Access Compliance Report

Public Rights-of-Way

(Curb Ramps)

Intersection ID: 12244	Main Street: BELMONT_AV	Cross Street: HARRILL_ST	Location: W
ADA ID: E99CCA3CA8DB	Ramp Type: Perp	Initial Pass/Fail: Fail	Overall Compliance: No
Severity Score: 8.75			
Codes/Mitigation Info/Possible Solution		Field Measurements/Component Compliance

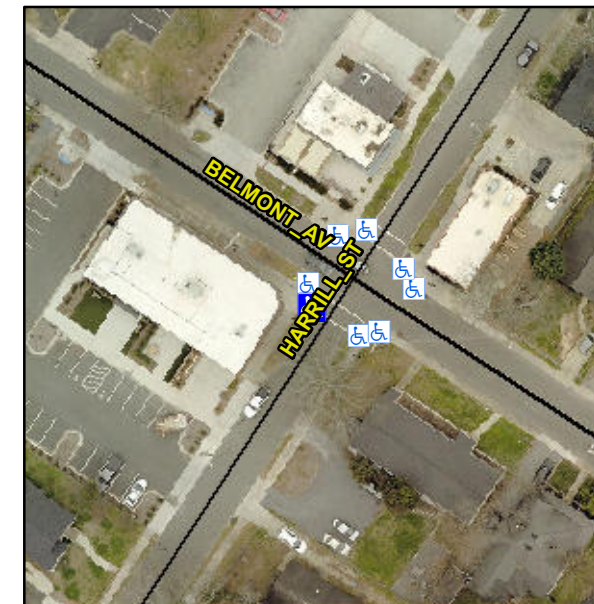
Not Found, R304.5.1

Compliance	Description	Data	Compliance	Description	Data
N/A	Ramp Length (in)	87.5	Yes	Ramp Slope (%)	7.8
No	Ramp Width (in)	47.0	Yes	Ramp XSlope (%)	1.2
N/A	Flare Type LT	N/A	N/A	Flare Type RT	N/A
N/A	Flare Slope LT (%)	N/A	N/A	Flare Slope RT (%)	N/A
N/A	Flare Traversable LT?	N/A	N/A	Flare Traversable RT?	N/A
N/A	Landing Length (in)	N/A	N/A	DWS Provided?	N/A
N/A	Landing Width (in)	N/A	N/A	DWS Contrast?	N/A
N/A	Landing Slope (%)	N/A	N/A	DWS Length (in)	N/A
N/A	Landing X Slope (%)	N/A	N/A	DWS Full Width?	N/A
N/A	Landing Curb? (Y/N)	N/A	N/A	DWS Offset (in)	N/A
N/A	Shared Landing?	N/A			
N/A	Gutter Ponding?	Yes	N/A	Gutter Slope (%)	N/A
N/A	Gutter Lip Ht (in)	N/A	N/A	Gutter X Slope (%)	N/A
N/A	Painted X Walk1?	Yes	N/A	Painted X Walk2?	N/A
	X Walk 1 Direction	To SE		X Walk 2 Direction	N/A
N/A	X Walk 1 Width (in)	96.0	N/A	X Walk 2 Width (in)	N/A
	X Walk 1 Slope (%)	7.2		X Walk 2 Slope (%)	N/A
	X Walk 1 X Slope (%)	3.0		X Walk 2 X Slope (%)	N/A

N/A	Ramp inside XWalk1?	Yes	N/A	Ramp inside XWalk2?	N/A
	Road Slope (%)	N/A	N/A	Clear Space?	N/A
	Road X Slope (%)	N/A	N/A	Clear Space to XWalk (in)	N/A
N/A	Any Obstructions?	N/A	N/A	Storm Grate/Utility Hazard?	N/A
	Obstruction Type			Storm Grate/Utility Type	
		N/A			N/A
		Yes		Surface Condition? (G/P)	Good

Remove & Replace Entire Ramp.
